Subject: 46-52 Nicholson Street and 57-67 Christie Street, St Leonards - Planning Proposal

Record No: SU8044 - 70375/20

Division: Environmental Services Division

The purpose of this report is to consider the planning merits for land at 46-52 Nicholson Street and 57-67 Christie Street, St Leonards to redevelop the site as a commercial office building.

Figure 4: Sketch of proposal.

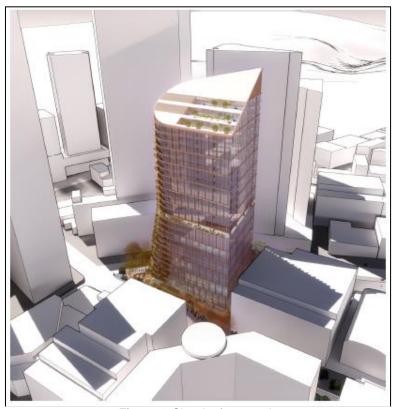
The proposed height of the building is 32 storeys, which is two storeys higher than the 2036 indicative height. Similarly, the proposed FSR is 16.45:1 which is 1.45:1 above the 15:1 of the 2036 Plan.

Additionally, the 3m ground level setback and 4 storey street wall height, which are consistent with the 2036 Plan, create an undesirable built form in terms of bulk and scale.

Notwithstanding the proposal's compliance with the 2036 Plan for setbacks and street wall heights, variations to the indicative FSR and height in storeys is not supportable from an amenity perspective.

Modifications to the height, FSR and setbacks of the proposal were investigated by Council and are addressed elsewhere in this report (refer to *Amended proposal – Architectus*).

Figure 7: Shadow modelling at 10am

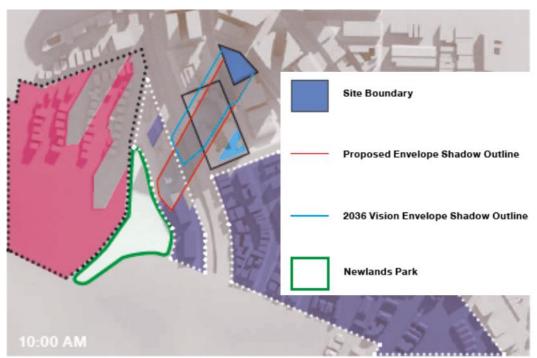
Notwithstanding that, shadow modelling in Figure 7 shows that the proposed building will not overshadow Newlands Park at all after 10am mid-winter. Therefore, the proposed LEP height control in the Planning Proposal is no longer applicable or consistent with the action of the final 2036 Plan.

An RL, as seen in the applicant's proposal (RL 198.6 metres) and/or equivalent height in metres gives assurance of height to adjoining land owners. Based on the above, the definition of height in terms of a solar height plane is uncertain and unnecessary in this Planning Proposal due to a new action in the final 2036 Plan.

Figure 9: Ground Floor Plan of proposal.

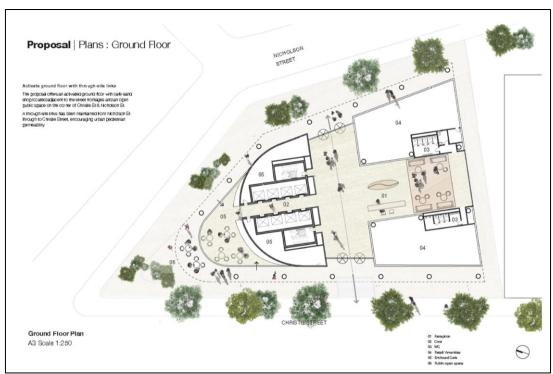
The proposed ground floor plan (Figure 9) shows that there is consistent street tree planting proposed along both street frontages (Nicholson and Christie Streets) but the exact amount of tree canopy cover has not been specified by the proponent.

However, there are no direct actions in the 2036 Plan on tree canopy cover which affect this site. Notwithstanding this, it appears that there is potentially enough space to accommodate increased tree planting if needed, based on the proposed ground floor plan.

Figure 10: Heights and building envelopes with Council's preferred proposal (26 storeys).

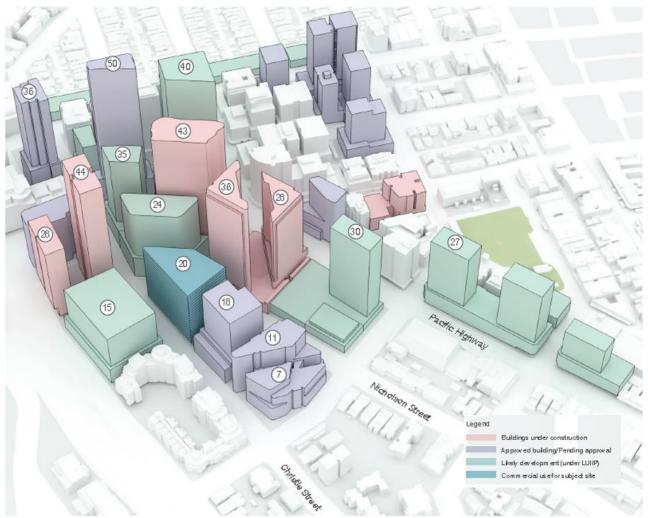
The reduction in height responds to the concerns raised above, by minimising the impacts of over-looking and loss of district views to adjoining/neighbouring residences, as well as transitioning the height and bulk more appropriately to the surrounding context (see figure 10).

It is noted that this revised building envelope is not consistent with Council's current DCP or the 2036 Plan for all setbacks. However, given the amendments to the height of the building, this approach provides a balanced position regarding setbacks between the applicant's proposal, the 2036 plan and the DCP.

- 26 storeys, with 24 office floors plus a plant level plus part rooftop plant;
- 15:1 FSR;
- 8 storey podium (street wall height) with 0m setback along Christie Street;
- 3m setback to Nicholson Street and southern boundary (rear); and
- 3m setback above podium.
